# **Manual 03A, Rev. 25**

## **Energy Management System (EMS) Model Updates and Quality Assurance (QA)**

System Operations Committee

Sept 25, 2024

Exhibit 10: Sample Format for 6-Week Look Ahead Cut-in Report

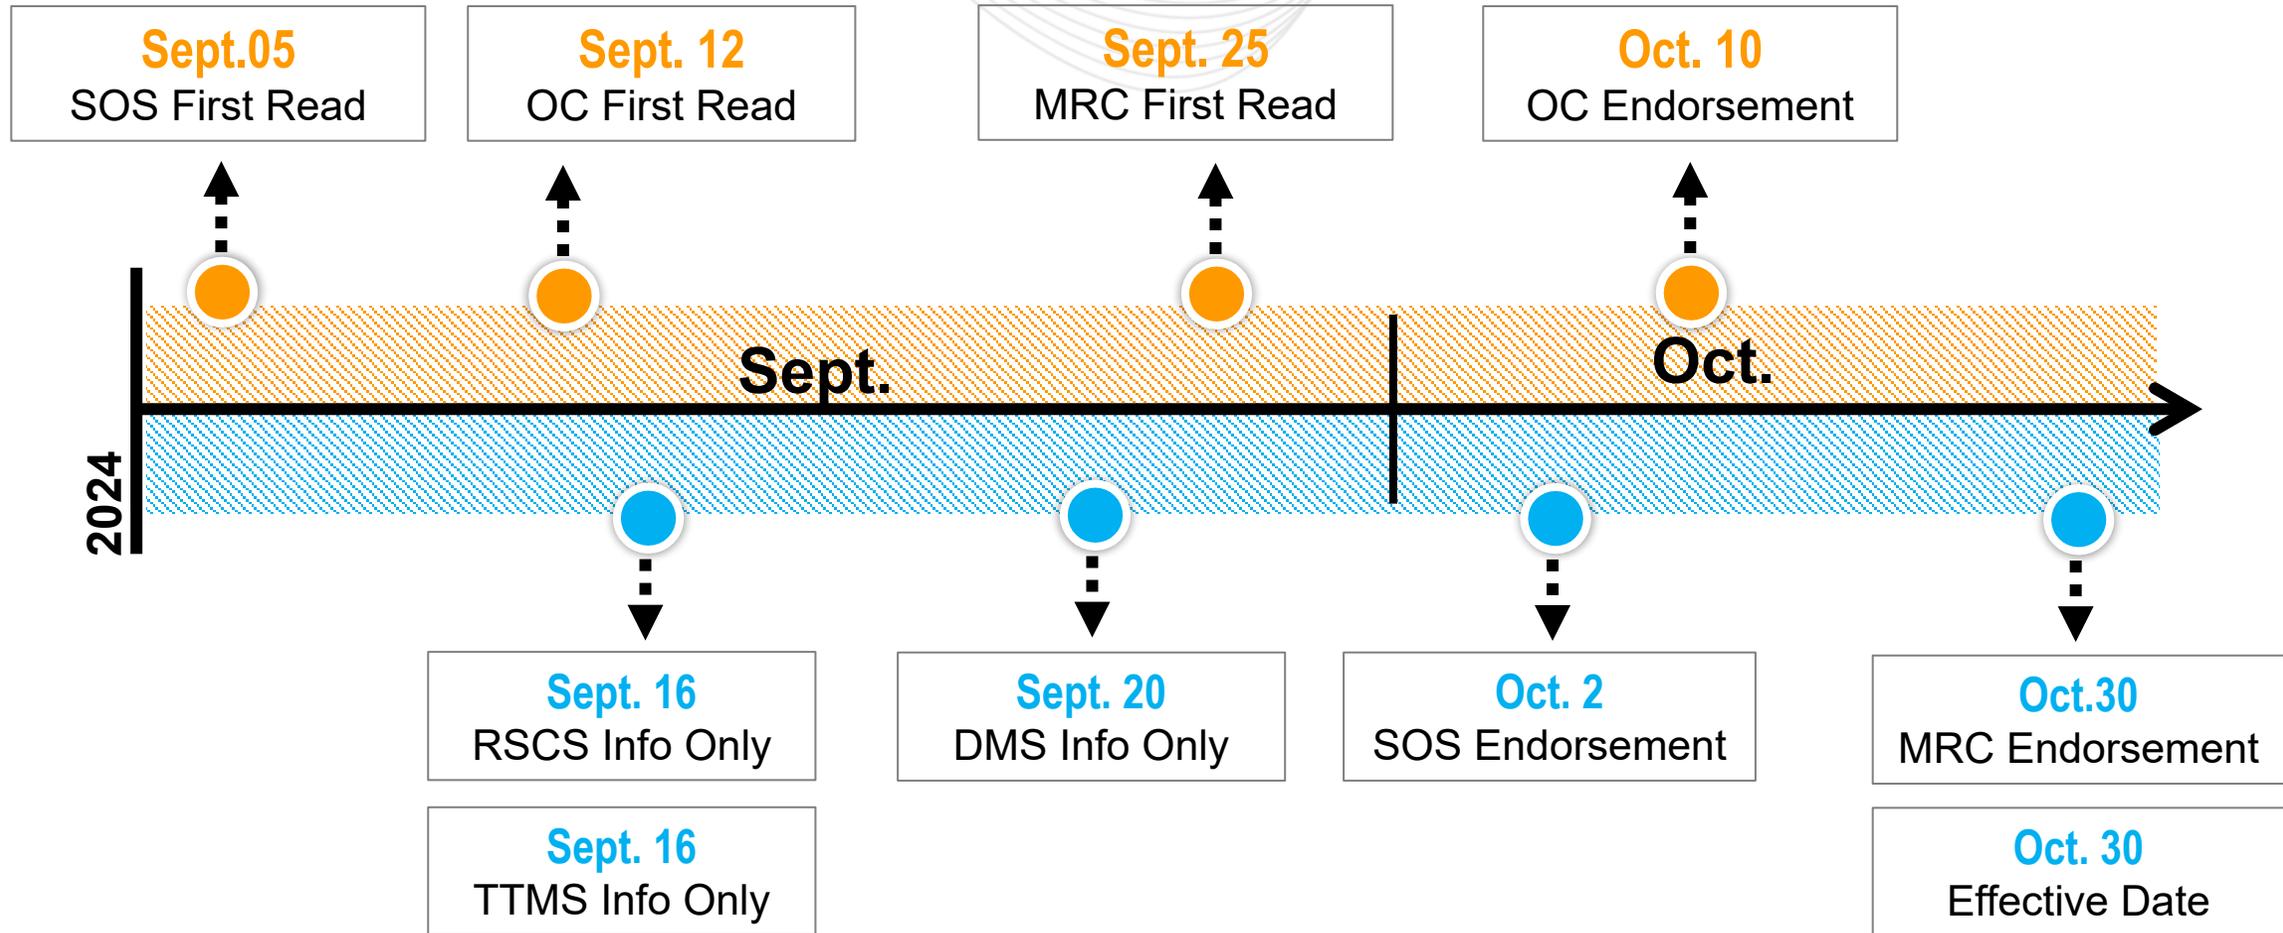
# Section 4.5: Removed Exhibit 10

- Remove Exhibit 10  
Outdated process was replaced via “Cut-in Barron” weekly reports

To facilitate the Cut-in process, PJM performs outreach to each TO with Cut-in related work in the Operations time horizon. will publish a weekly list of scheduled outages in eDART that have the Cut-in flag set. The reports include a six (6)-week look-ahead of all outages tickets that have the Cut-in flag set. See Exhibit 10 below.
